TITLE: BLANK, SLEEVE

SIZE D | DWG NO T33-125-350-02B | REV 3

PROTO/QUOTE

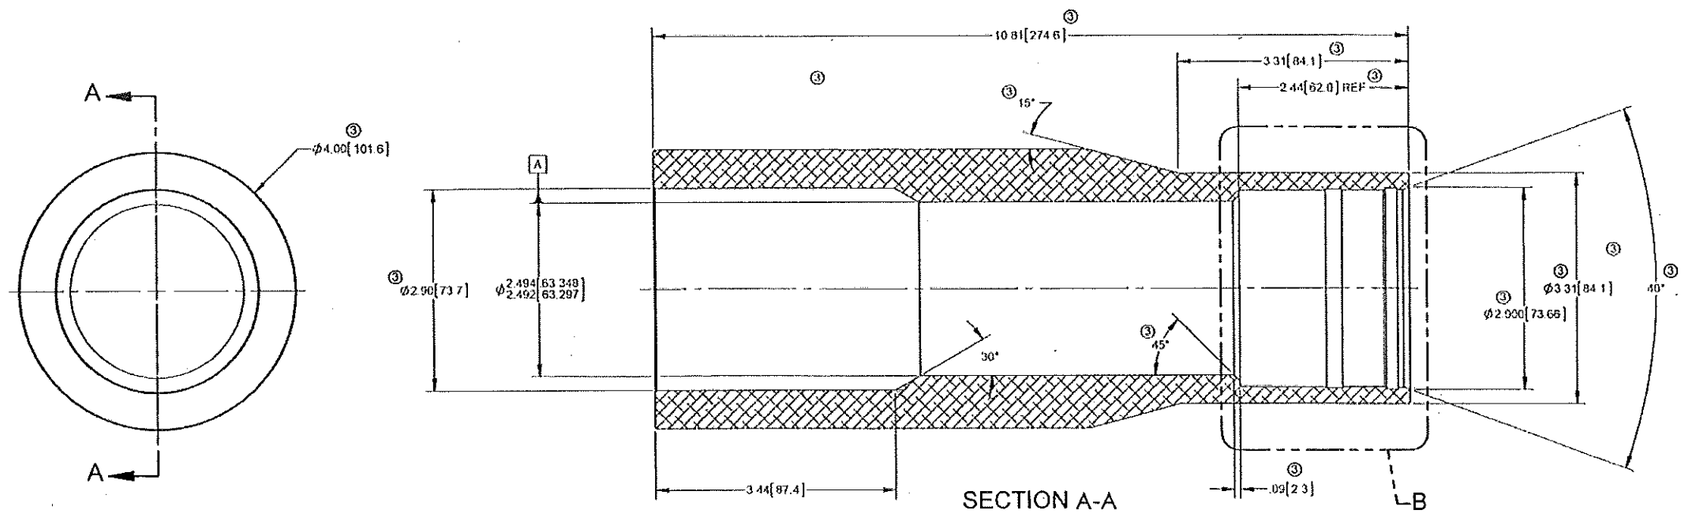
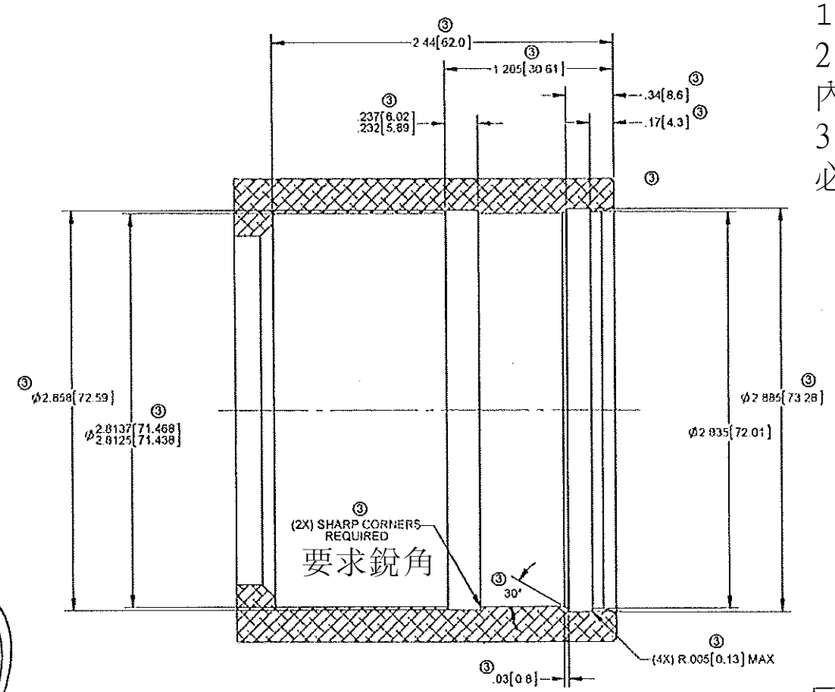
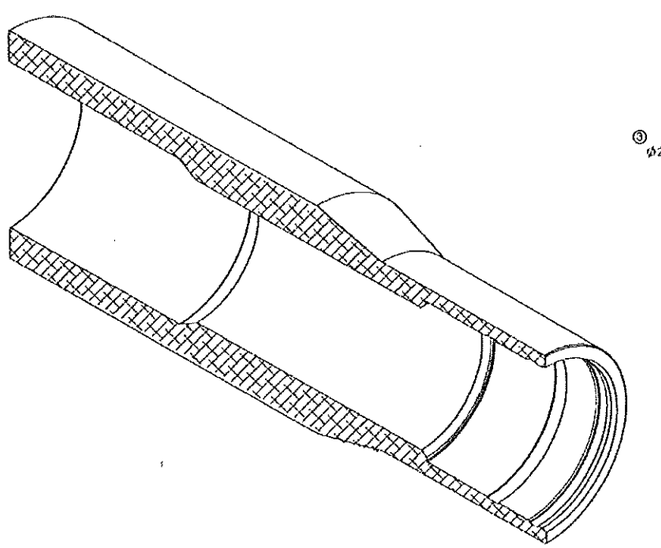
DRAWING REVISION INFORMATION			
REV	DESCRIPTION	DRAWN BY	ISSUE DATE
3	REVISED: Ø4.00 [101.6] WAS Ø3.76 [95.3], Ø2.90 [73.7] WAS Ø2.84 [72.1], 15° WAS 15° REF, 10.81 [274.6] WAS 9.06 [230.1], 3.31 [84.1] WAS 2.00 [50.8] REF, Ø3.31 [84.1] WAS Ø3.38 [85.9] REF, Ø2.885 [73.28] WAS Ø2.925 [74.30], .34 [8.6] WAS .38 [9.7], .17 [4.3] WAS .18 [4.6] ADDED: Ø2.858 [72.59], Ø2.8137/2.8125 [71.468/71.438], 2.44 [62.0], .237/.232 [6.02/5.89], 1.205 [30.61], (4X) R.005 [0.13] MAX, .03 [0.8] X 30° CHAMFER, (2X) SHARP CORNERS, Ø2.900 [73.66] X 40° CHAMFER, .09 [2.3] X 45° CHAMFER, 2.44 [62.0] REF REMOVED: .09 [2.3] X 30° CHAMFER, .50 [12.7] DIM, ALTERNATE MATERIAL T33-125-350-02F (NOTE 1), Ø3.62 [91.9], 7.87 [199.9], R.44 [11.2]	BTC	02/20/13
